| APPLICATION NO.        | FILING DATE | FIRST NAMED INVENTOR | ATTORNEY DOCKET NO. | CONFIRMATION NO. |
|------------------------|-------------|----------------------|---------------------|------------------|
| 10/681,983             | 10/09/2003  | Chun Ho Fan          | 50626.60            | 8846             |

| <b>Office Action Summary</b> | <b>Application No.</b><br>10/681,983 | <b>Applicant(s)</b><br>FAN ET AL. |  |

## DETAILED ACTION

**FIG. 5.*****Claim Rejections - 35 USC § 103***

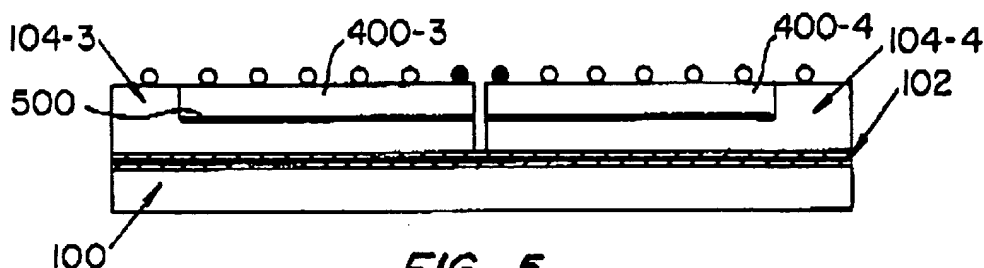
3. Claims 11 is rejected under 35 U.S.C. 102(e) as being anticipated by Joshi (US 6,627,991).

4. Regarding claim 11, Mita (e.g. fig. 5) shows a integrated circuit package comprising: a first lead frame 104; a second lead frame 100 laminated to a portion of the first lead frame in order to create a multi layer lead frame; and a semiconductor 400 mounted to another portion of the lead frame; and a plurality of contact balls mounted on the semiconductor die.
